5020 N. INTERSTATE

APPLICANT APPEAL 1

NEIGHBORHOOD APPEAL

WEST UNIT ENTRY ELEVATION

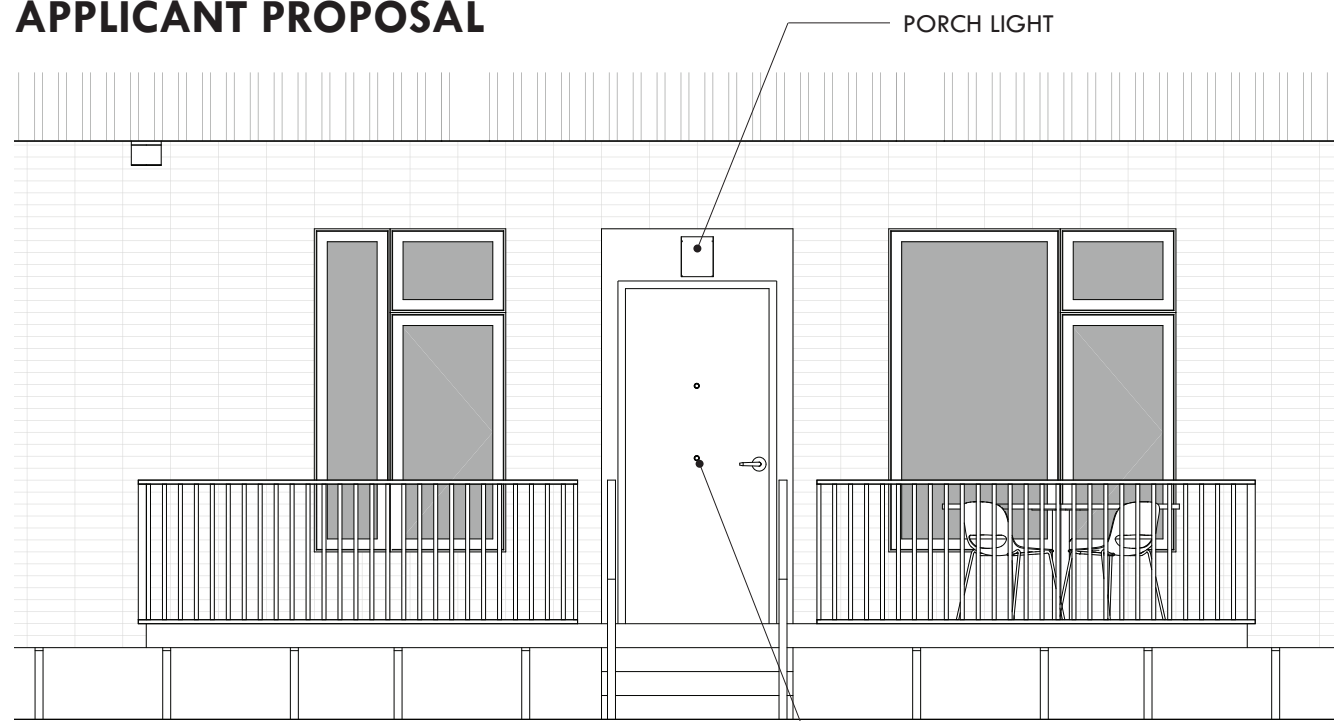
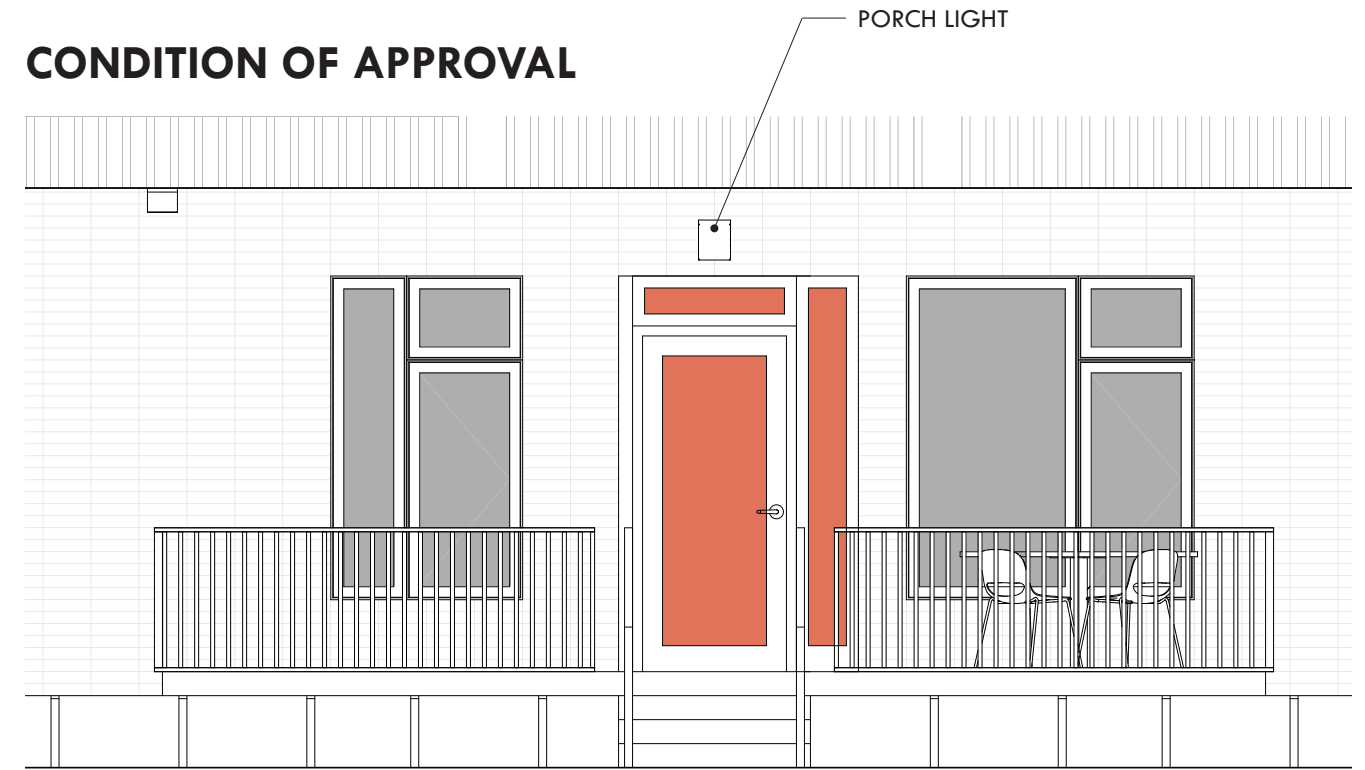
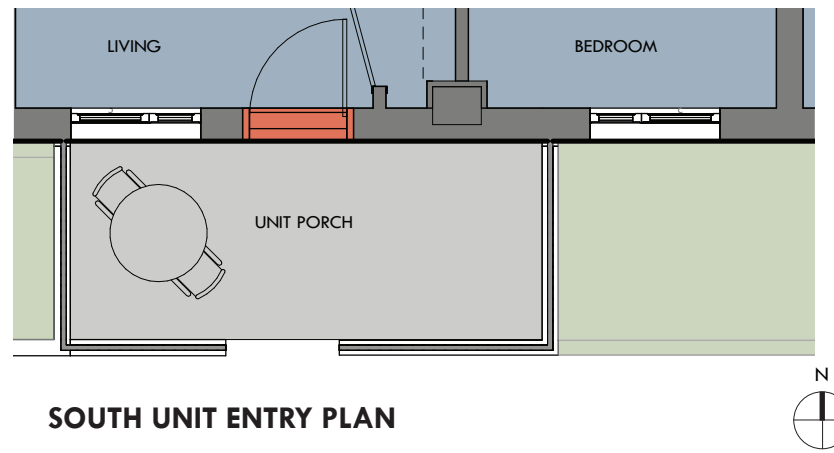
CONDITION OF APPROVAL 3

“DOORS WITH FULL LIGHTS AND TRANSOM WINDOWS ABOVE SHALL BE PROVIDED AT THE FOUR GROUND-LEVEL RESIDENTIAL UNIT ENTRIES. SIDELIGHTS SHALL ALSO BE PROVIDED AT THE TWO GROUND-LEVEL RESIDENTIAL UNIT ENTRIES FACING N. INTERSTATE AVE.”

CONDITION OF APPROVAL REQ'D GLAZING AT UNIT ENTRY

- 31% GROUND FLOOR RESIDENTIAL USE GLAZING EXCEEDS 25% MINIMUM REQUIREMENT FOR CM3 ZONE
- SOLID DOOR BALANCES DIRECT ACCESS TO TRANSIT STREET WITH SECURITY AND NOISE CONCERNS FOR RESIDENTS OCCUPYING UNIT
- ENTRY DOOR DETAILED WITH RECESSED BREAK METAL PANEL IN BRICK; DOOR PAINTED YELLOW ACCENT COLOR TO ADD INTEREST AND RELATE TO BUILDING CHARACTER OF UPPER FLOORS

- FULL LIGHT DOOR, SIDE LIGHT, AND TRANSOM WINDOWS AROUND ENTRY DOOR NOT NECESSARY WITH BOTH BEDROOM AND LIVING ROOM WINDOWS FACING ENTRY PORCH ALONG N. INTERSTATE

SOUTH UNIT ENTRY ELEVATION

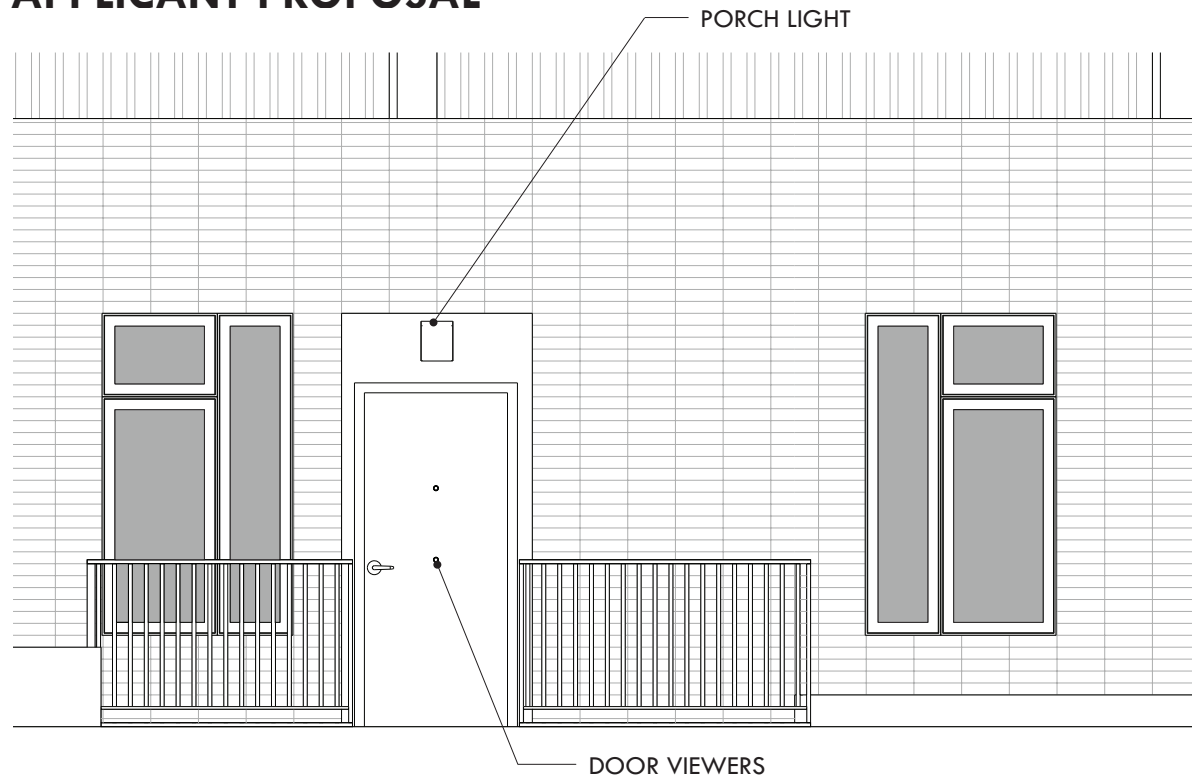
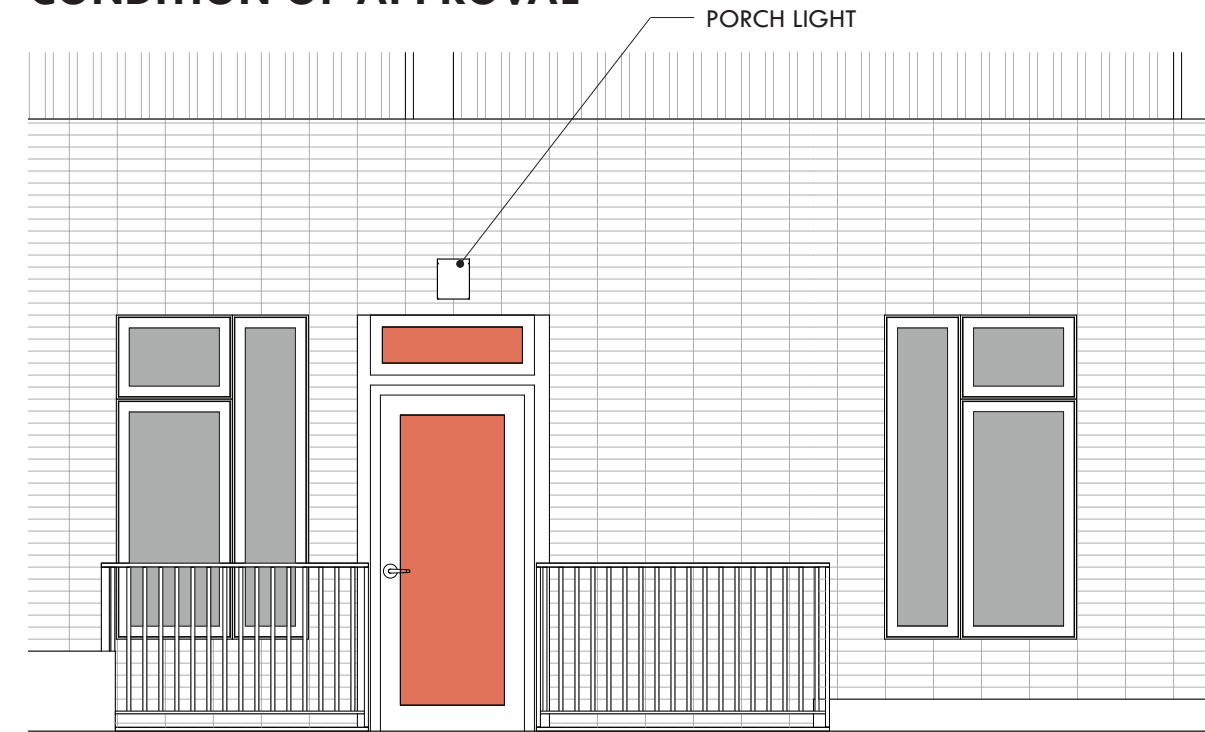
CONDITION OF APPROVAL REQ'D GLAZING AT UNIT ENTRY

- 26% GROUND FLOOR RESIDENTIAL USE GLAZING EXCEEDS 25% MINIMUM REQUIREMENT FOR CM3 ZONE
- SOLID DOOR BALANCES DIRECT ACCESS TO TRANSIT STREET WITH SECURITY AND NOISE CONCERNS FOR RESIDENTS OCCUPYING UNIT
- ENTRY DOOR DETAILED WITH RECESSED BREAK METAL PANEL IN BRICK; DOOR PAINTED YELLOW ACCENT COLOR TO ADD INTEREST AND RELATE TO BUILDING CHARACTER OF UPPER FLOORS

- FULL LIGHT DOOR AND TRANSOM WINDOWS AROUND ENTRY DOOR NOT NECESSARY WITH BOTH BEDROOM AND LIVING ROOM WINDOWS FACING ENTRY PORCH ALONG N. ALBERTA

GROUND FLOOR PLAN

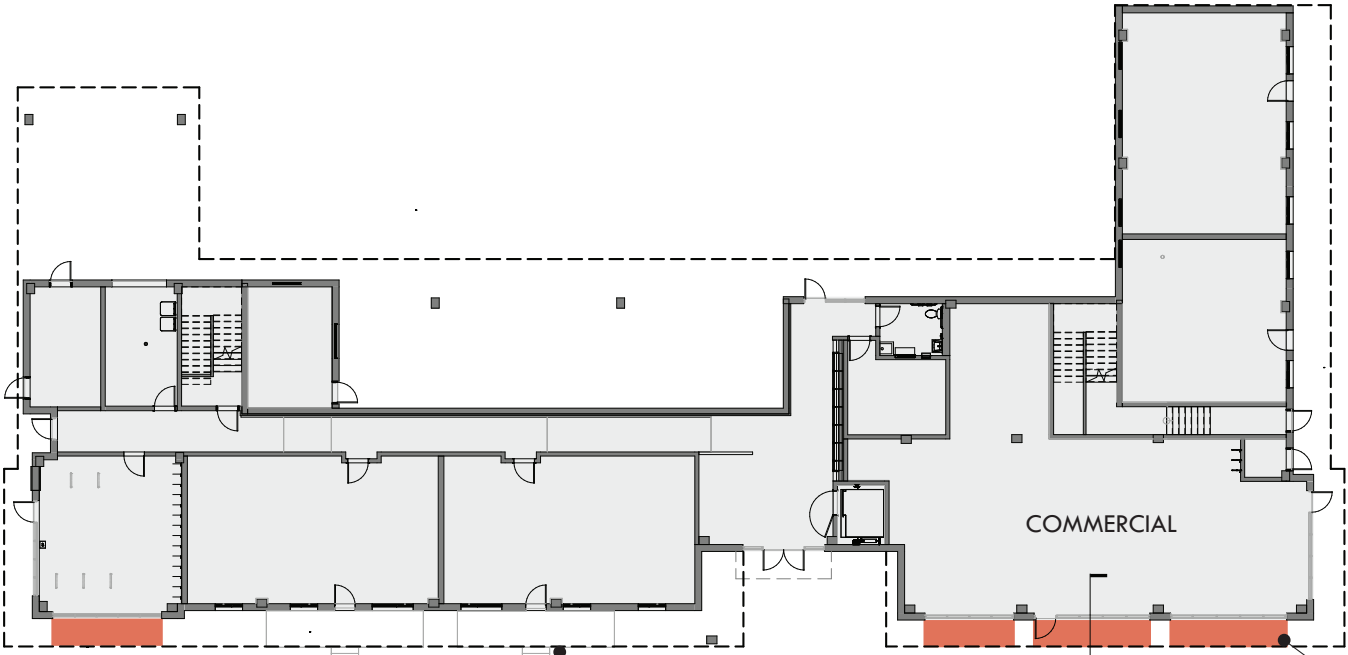
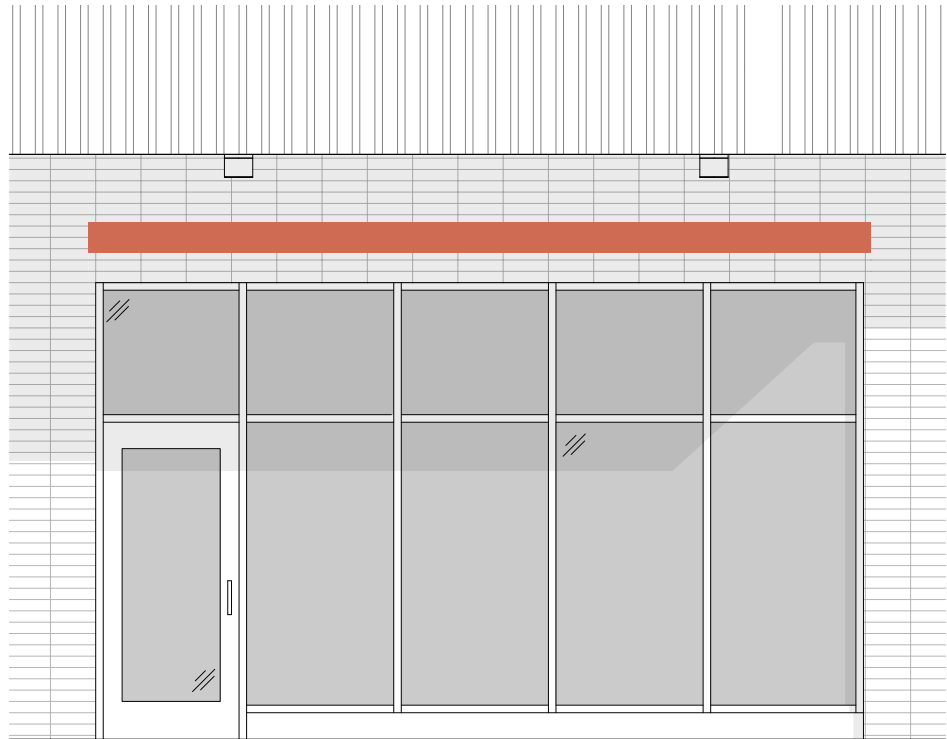
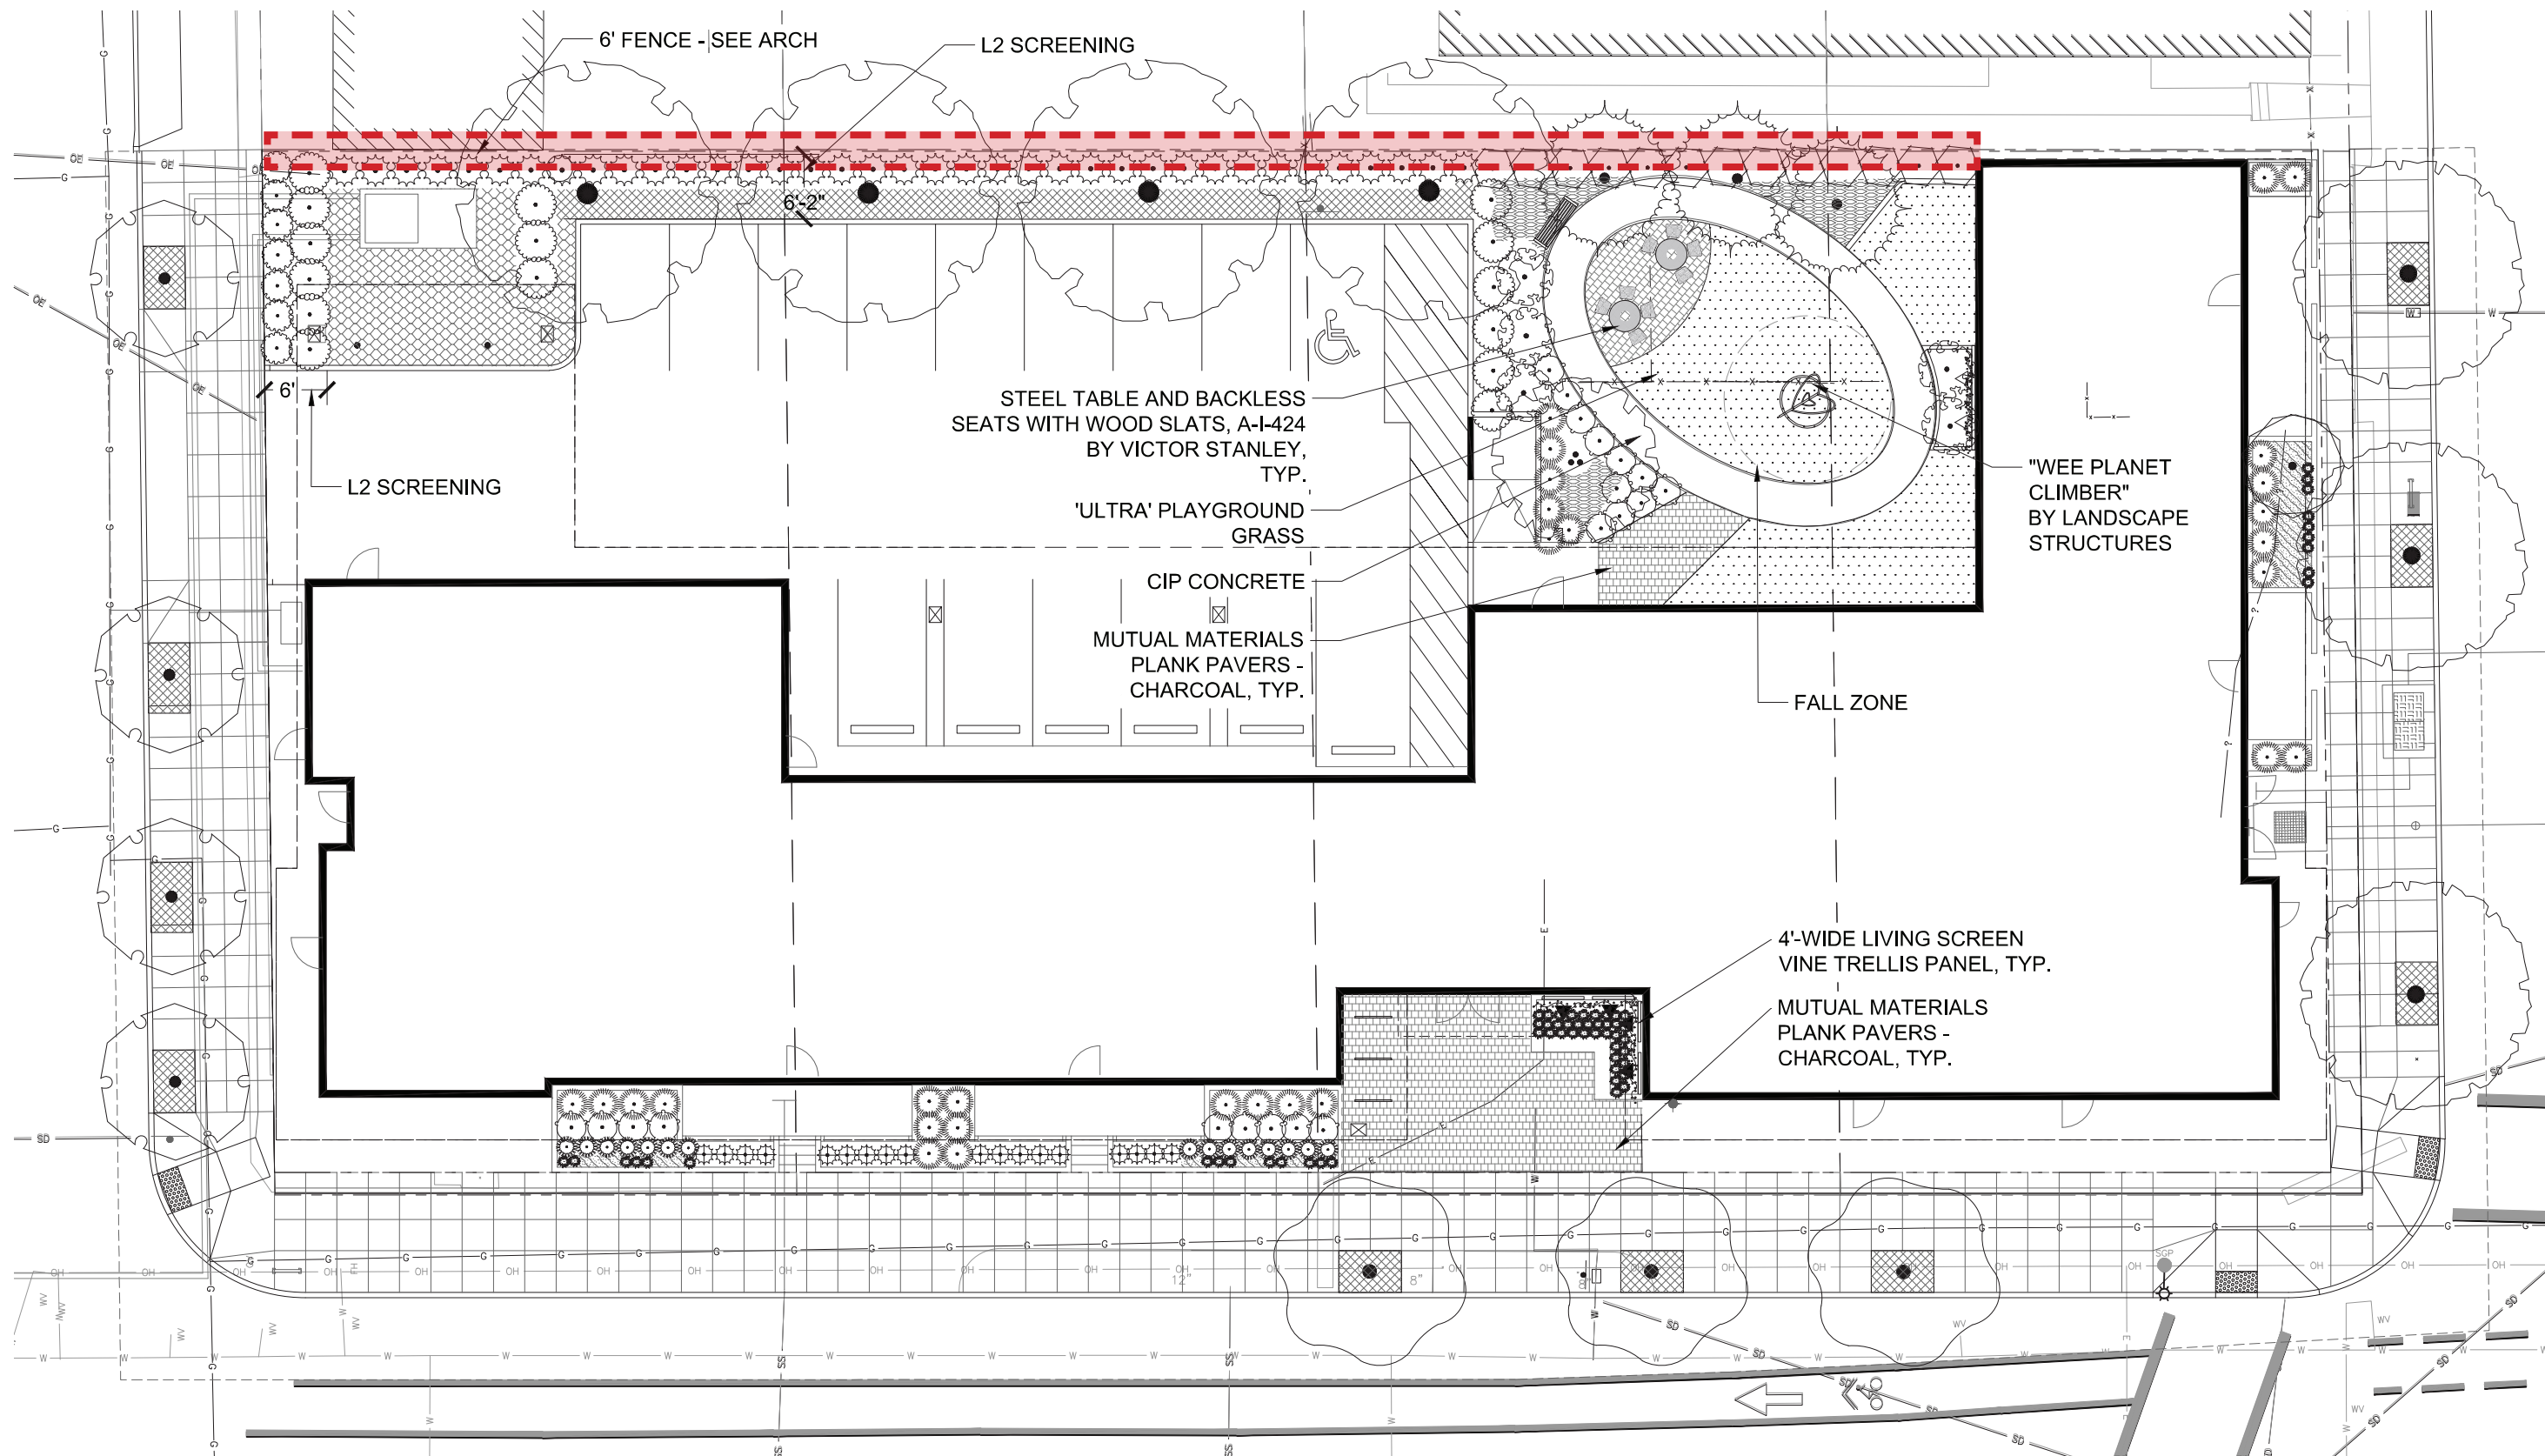
CONDITION OF APPROVAL 4

“A CANOPY OR AWNING SYSTEM SHALL BE PROVIDED AT A MINIMUM 4’-0” DEPTH FOR THE LENGTH OF EACH STOREFRONT WINDOW BAY ON THE WEST ELEVATION OF THE COMMERCIAL SPACES AT THE SOUTHWEST AND NORTHWEST CORNERS OF THE BUILDING. THESE CANOPIES OR AWNINGS SHALL ALL BE APPROVED THROUGH EITHER A FOLLOW-UP DESIGN REVIEW, OR THEY SHALL ALL MEET THE EXEMPTION FROM DESIGN REVIEW IN ZONING CODE SECTION 33.420.045.S.”

CONDITION OF APPROVAL REQ'D 4' DEEP CANOPY/AWNING SYSTEM

- PROTECTION OF PEDESTRIANS PROVIDED AT STOREFRONT AT NW CORNER BIKE ROOM LOCATION AND SW CORNER COMMERCIAL SPACE WITH BUILDING OVERHANG
- DEPTH OF OVERHANG VARIES. 3'-10 3/4" MIN. DEPTH LOCATED ALONG WEST FACING STOREFRONT OF COMMERCIAL SPACE. ALL OTHER LOCATIONS PROVIDE A MIN. 4' - 0" DEPTH

- ADDITION OF A 4'-0" DEEP CANOPY SYSTEM WHERE THERE IS ALREADY AN OVERHANG OF SIMILAR DEPTH IS REDUNDANT AND ADDS UNNECESSARY COST TO PROJECT
- A CANOPY / AWNING SYSTEM WAS NOT PART OF THE ORIGINAL DESIGN INTENT AND DOES NOT ALIGN WITH THE BUILDINGS DESIGN CHARACTER OF SIMPLE MASSES AND CLEAN LINES

CONDITION ADDS 64' - 1" OF CANOPY IN LINEAR FEET
